Staff Report

Re: PLNPCM2018-00158 and PLNSUB2018-00240 – Geronimo Shop Conditional Use and

Planned Development

PROPERTY ADDRESS: 1330 S 700 W **PARCEL ID:** 15-11-480-027-0000

Figure 1 - Proposed site plan

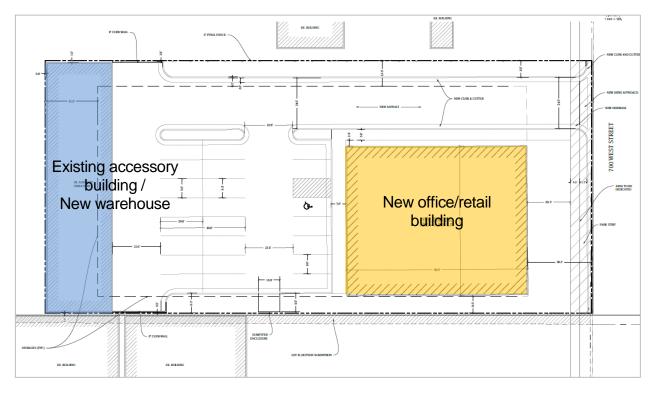
- The proposed development contains two principal buildings on the same lot.
- The applicant is seeking relief from interior side and rear yard requirements, including special landscape regulations, where compliance would preclude the preservation and use of the

- *Noise impacts:* Parking stalls will be situated closer to the south property line and approximately 32 feet from the residential properties to the north. Because these residential lots face 1300 S, the subject property is adjacent to its rear yards. Nonetheless, the driveway and required landscaping and fence will provide some distance from the commercial building and parking area, as well as additional buffering, to the residential areas.

- 1. Final landscape plan, lighting plan, and site plan with location of service areas shall be submitted to Planning staff for approval.
- 2. The proposal shall comply with all department and division requirements.
- 3. The applicant shall obtain the necessary permits for the new building as well as the change of use of the accessory building from the Building Services department.
- 4. Any modifications to the approved plans after the issuance of a building permit must be specifically requested by the applicant and approved by the Planning Division prior to execution.

Figure 3 - Proposed side facades of the new office/retail building

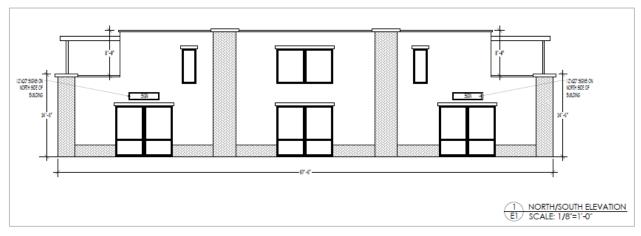
- existing accessory structure.
- The applicant is requesting approval of additional signage on the side and rear facades in order to accommodate the different businesses in the office/retail building.

14. Signs and lighting are compatible with, and do not negatively impact surrounding uses	Complies	The proposed signs are small, especially when compared to existing signs across the street, and are necessary to serve the retail business. Some of the signs will be partially or not at all visible from the street. Lighting plan will be submitted to Planning staff for approval. Approval will be granted for lighting necessary to provide safety on the site and minimized in order to not impact adjacent properties.

PRELIMINARY PLANS NOT FOR CONSTRUCTION _P-1.0

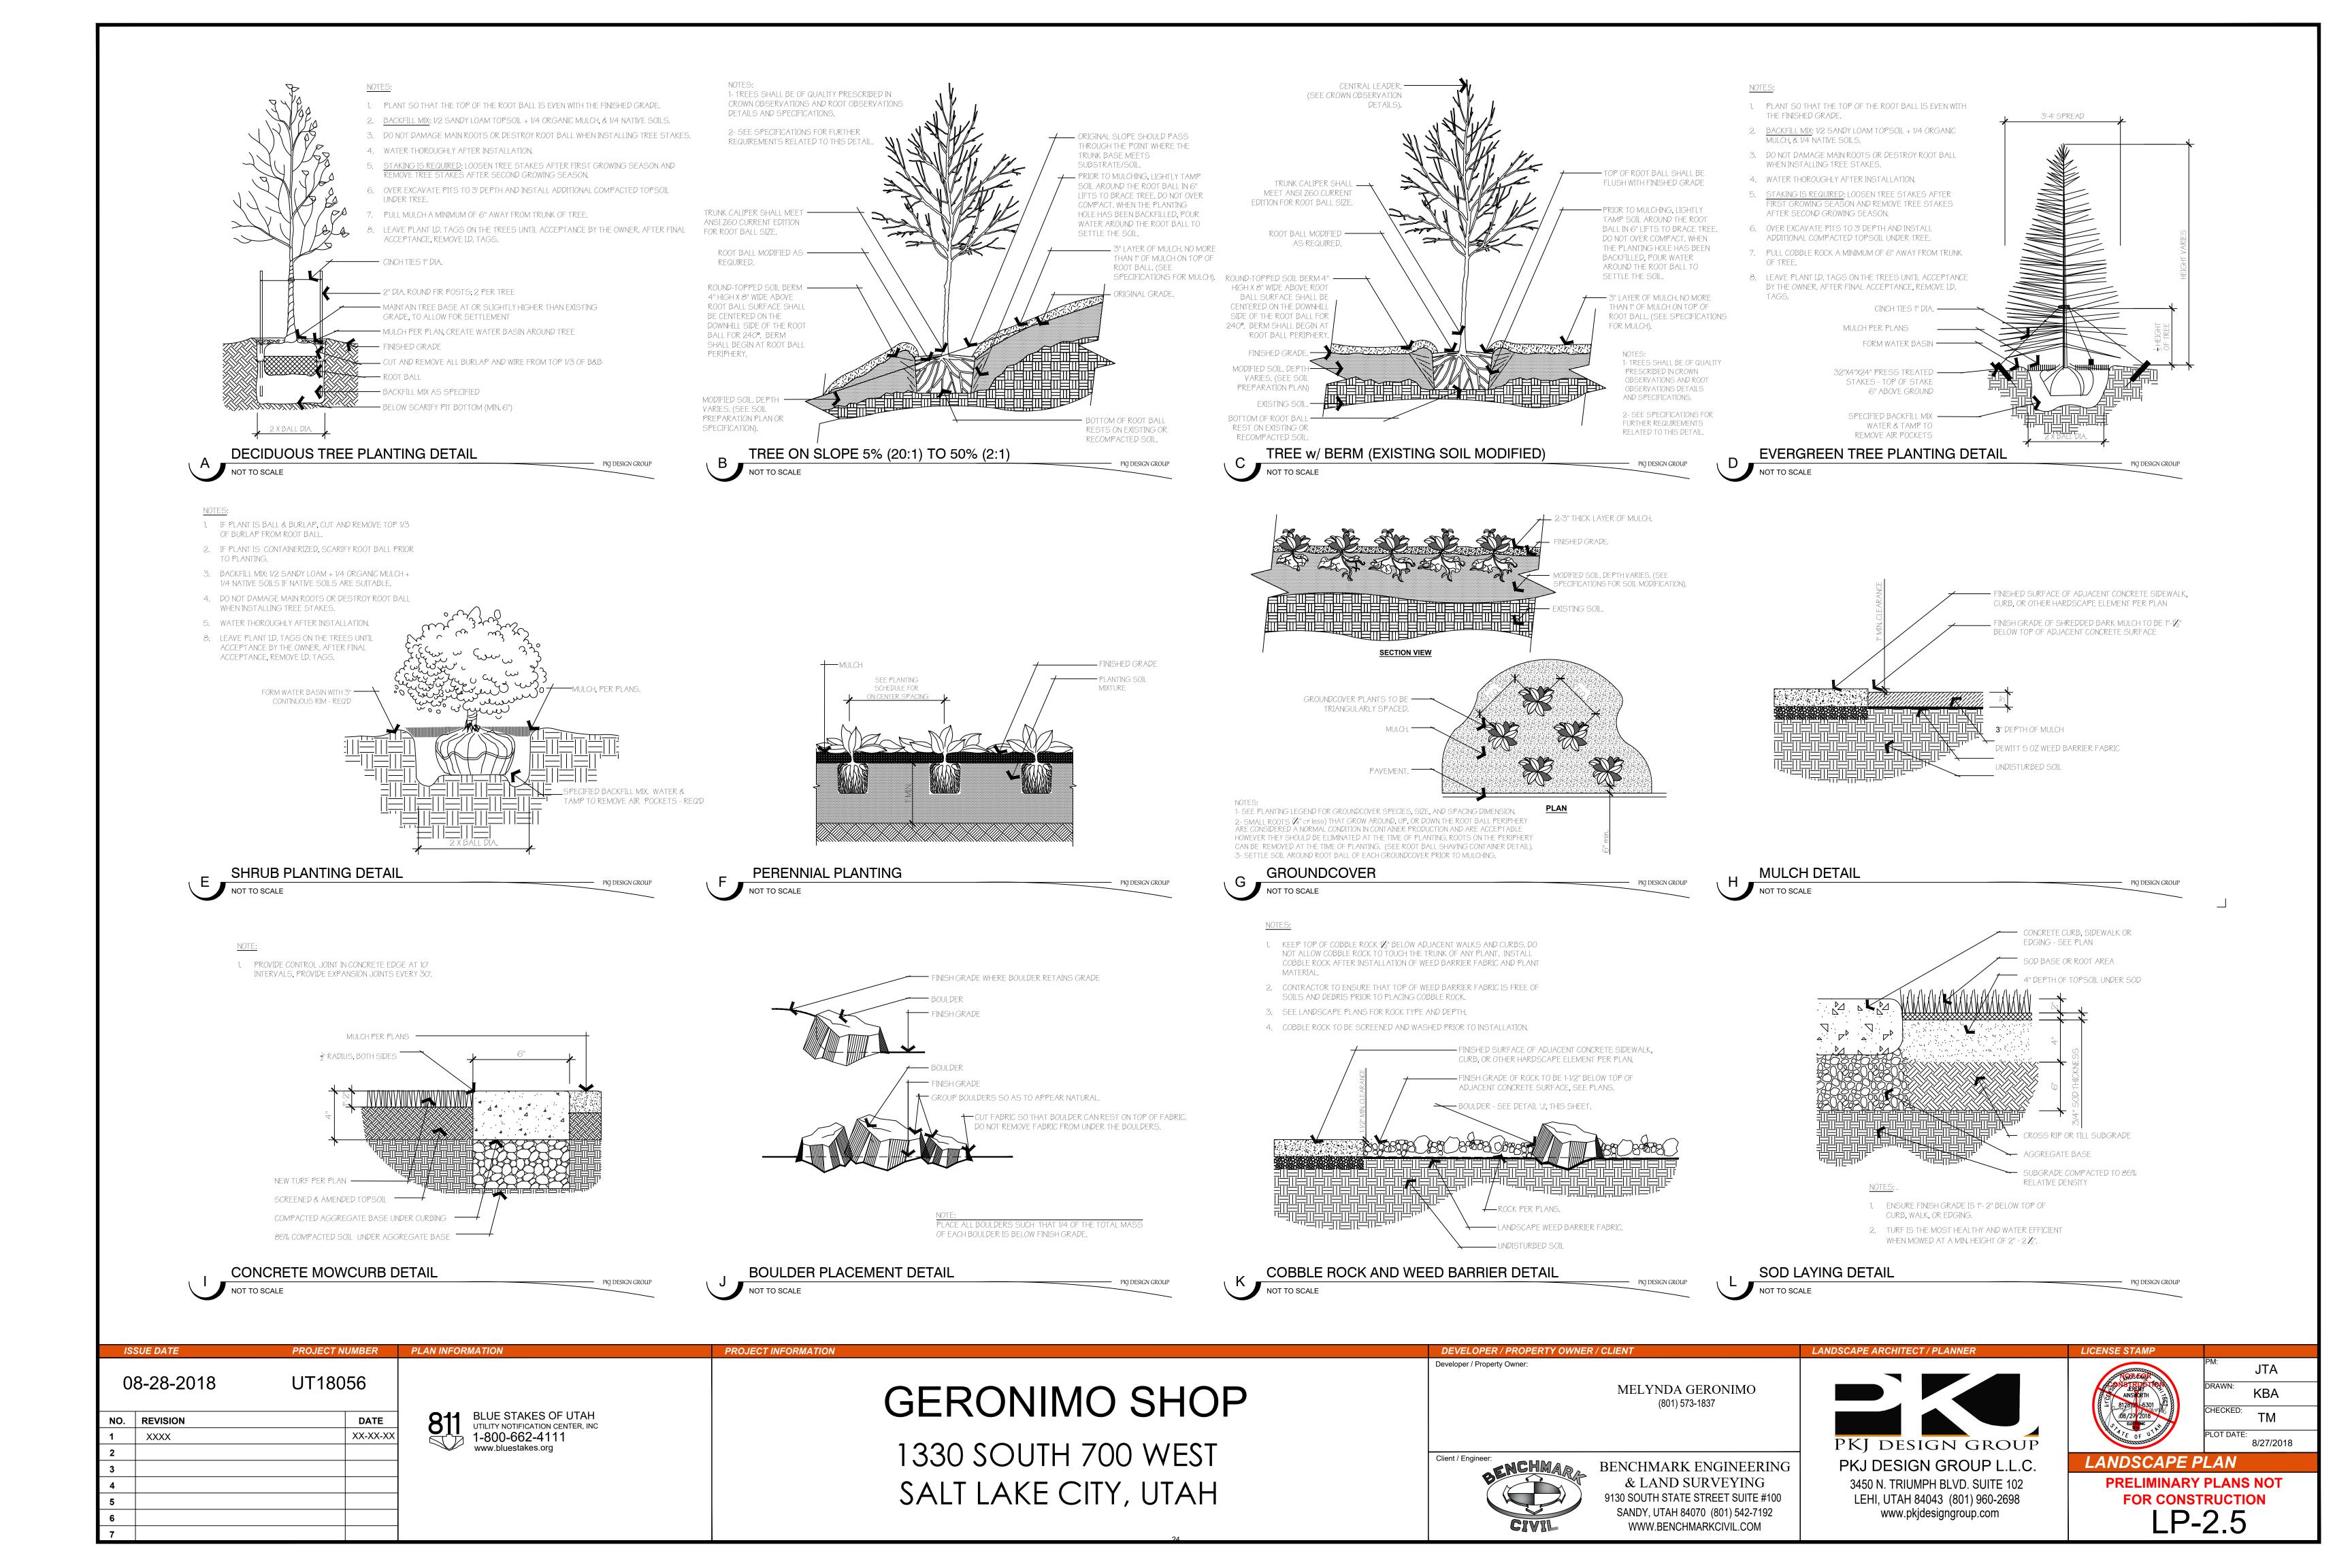
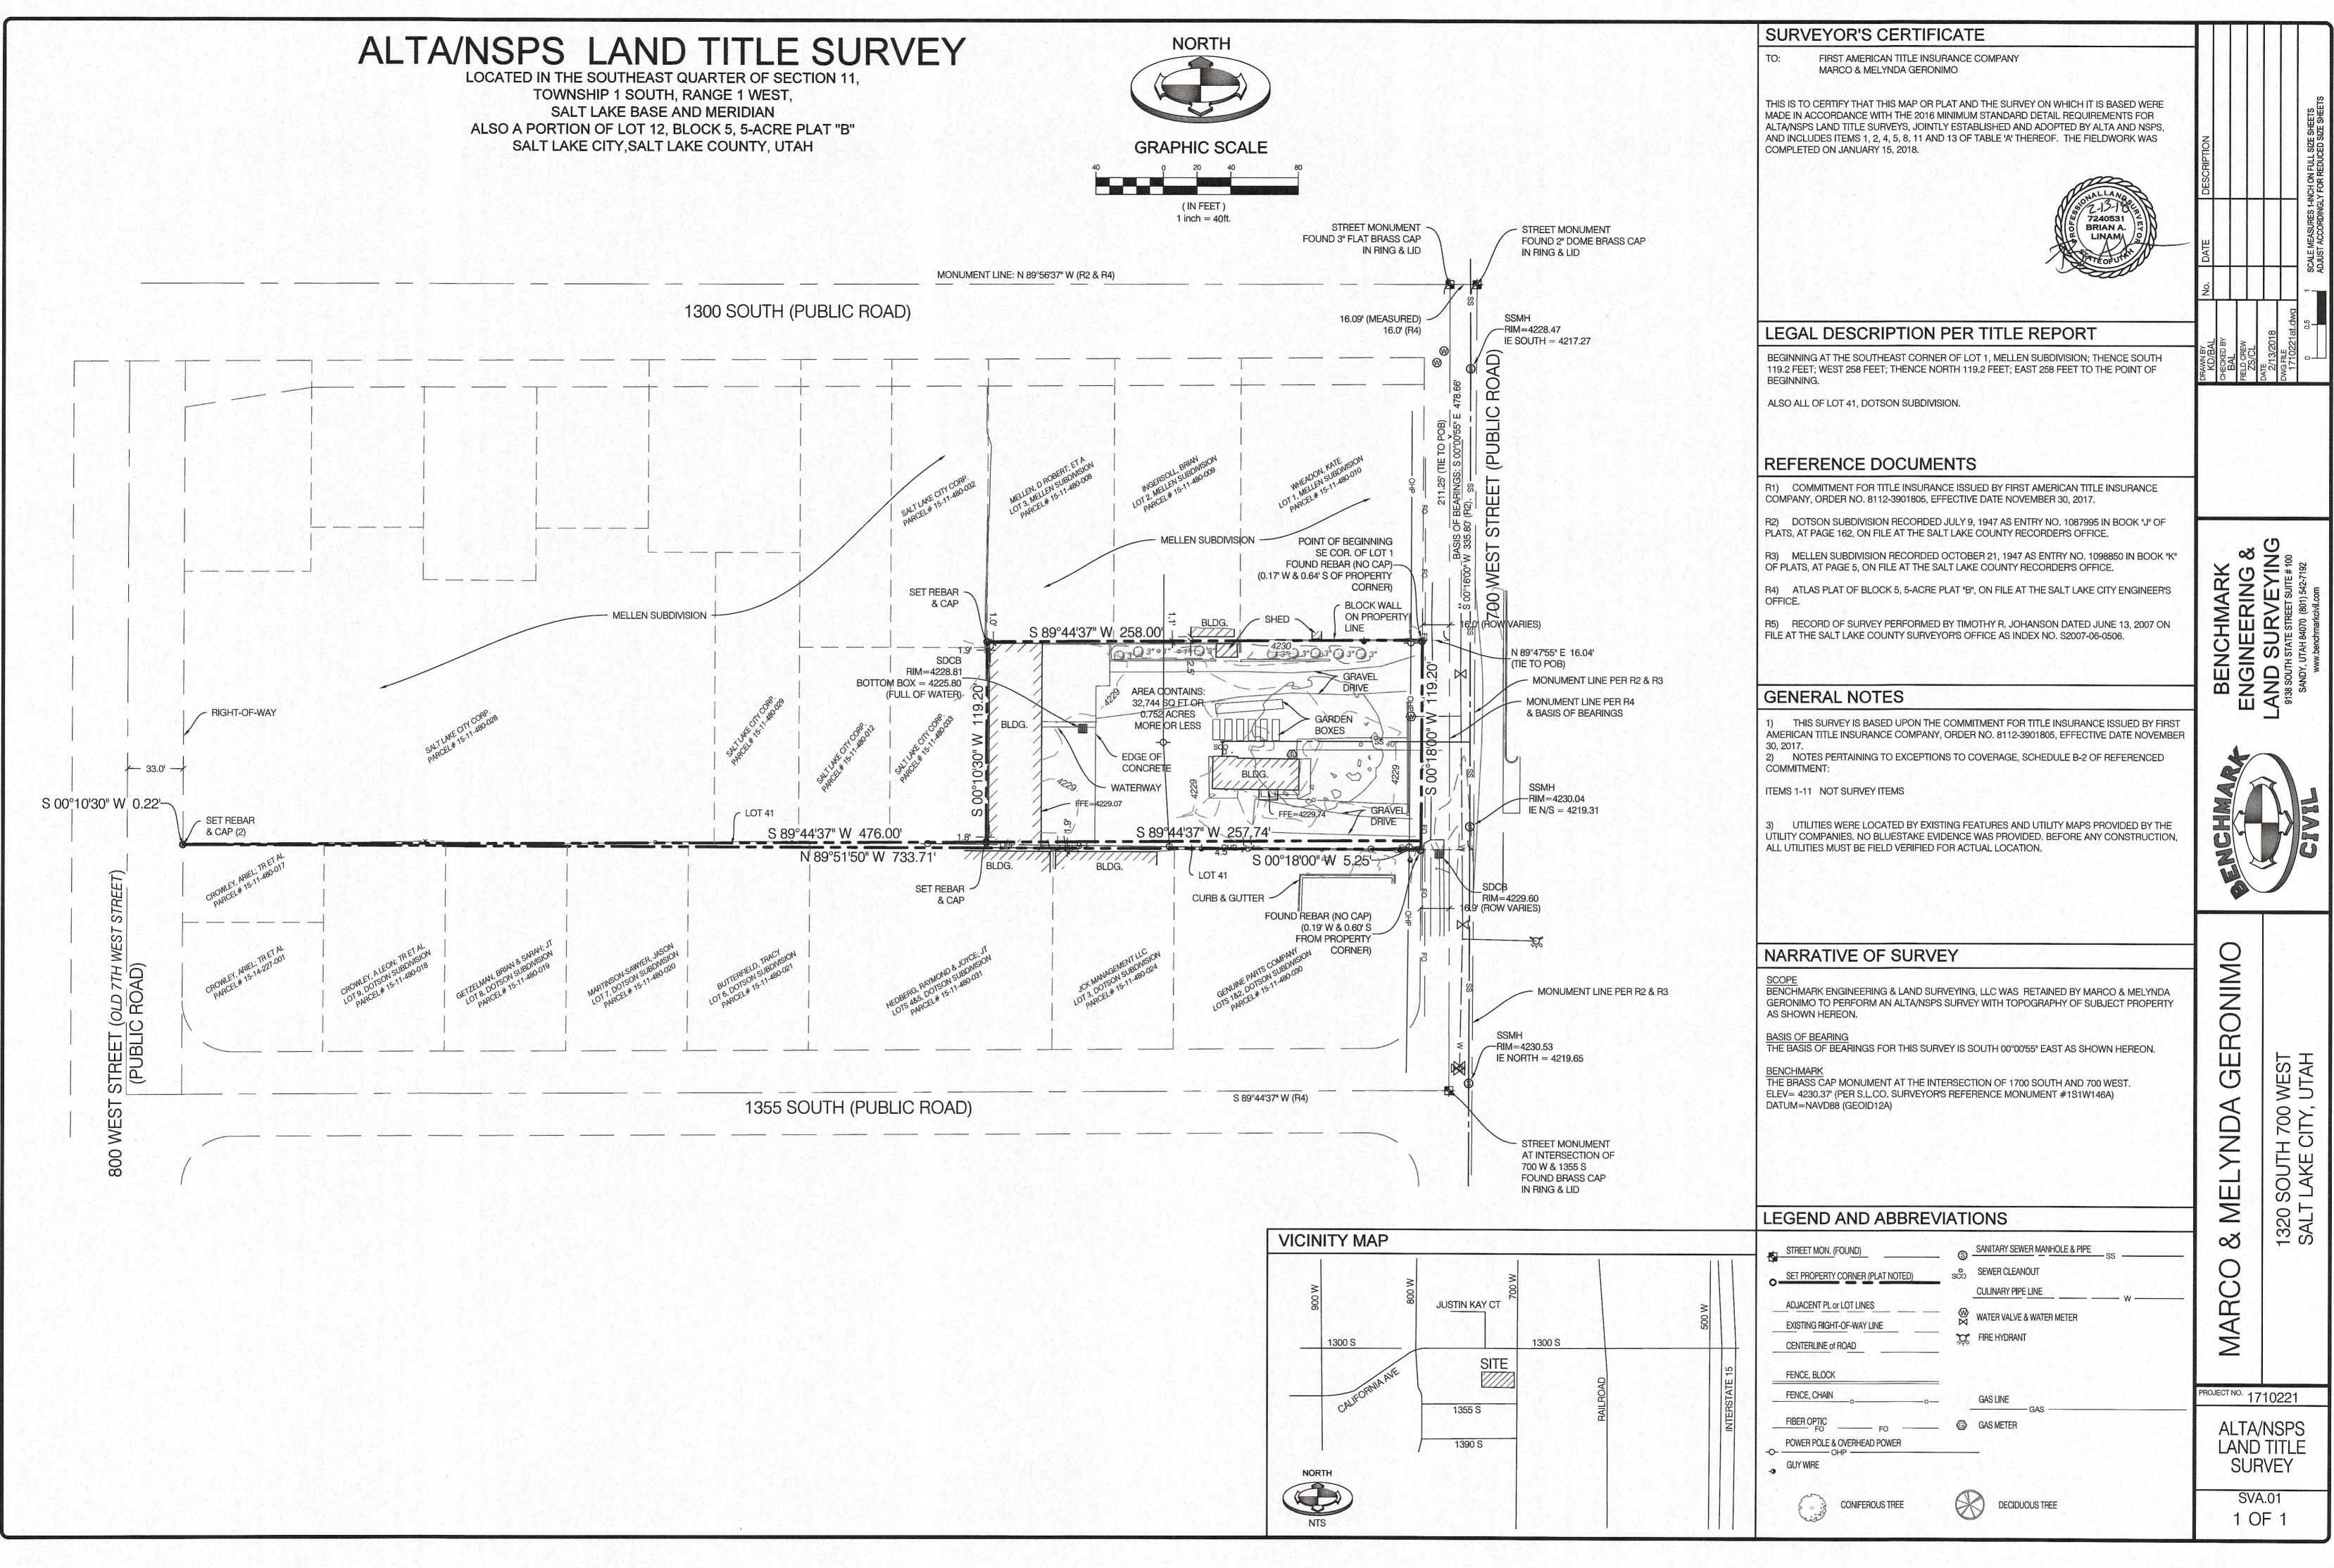
Maximum Sign area: 6 square feet	5 square feet	Complies
Landscaped Front Yard: The front yard shall be maintained as landscape yard and consistent with residential neighborhood	Front yard will be landscaped with trees and shrubs.	Complies
Landscaped Interior Yard abutting residential use: 8 feet with 6 foot solid fence, 1 tree per 30 feet of yard and continuous row of shrubs	Applicant must provide final landscape plan to Planning Staff for approval.	Complies with conditions

1. Whether mature native trees where buffering is required. located along the periphery of the property and along the street are 3. More trees than required is proposed in the preserved and maintained: buffer area. Final landscape plan will be submitted to Planning staff for compliance with 2. Whether existing landscaping that other Transitional overlay landscape buffer provides additional buffering to the requirements. abutting properties is maintained and preserved; 4. The proposed landscaping enhances the development with appropriate trees, shrubs and 3. Whether proposed landscaping is grasses. designed to lessen potential impacts created by the proposed planned development; and 4. Whether proposed landscaping is appropriate for the scale of the development. **E. Mobility:** The proposed planned Complies The proposed development includes creating development supports Citywide onsite and street sidewalks, as well as improving transportation goals and promotes one of the driveways and removing another. safe and efficient circulation within the site and surrounding 1. 1300 South and 700 West are arterial and neighborhood. In determining collector streets that can currently accommodate mobility, the Planning Commission significant traffic. The change in use is not should consider: expected to unreasonable impact the service level of those streets. 1. Whether drive access to local streets will negatively impact the 2. Sidewalks are proposed surrounding the new safety, purpose and character of the building and connecting the front entrance to the street sidewalk to safely accommodate pedestrian street: traffic. Conflict between pedestrian and vehicles is minimized with the new street sidewalk and 2. Whether the site design considers generally limited to the driveway access. The safe circulation for a range of proposed development also includes covered transportation options including: a. Safe and accommodating facilities for the required bicycle parking. pedestrian environment and 3. The proposed development includes a street pedestrian oriented design; b. Bicycle facilities and connections sidewalk that will connect with the existing where appropriate, and sidewalk to the south of the property. orientation to transit where 4. The design seemingly provides adequate available; and c. Minimizing conflicts between emergency vehicle access. The project will be reviewed for fire code compliance at time of different transportation modes; permitting. 3. Whether the site design of the proposed development promotes or 5. Site plan/floor plan with location of service areas will be submitted to Planning staff for enables access to adjacent uses and approval. Approval will be granted for service amenities: area that is properly screened and not be visible from the public way. 4. Whether the proposed design provides adequate emergency vehicle access; and 5. Whether loading access and service areas are adequate for the site and minimize impacts to the surrounding area and public rights-of-way. F. Existing Site Features: The Complies The site has no natural or built features that proposed planned development contribute to the character of the neighborhood
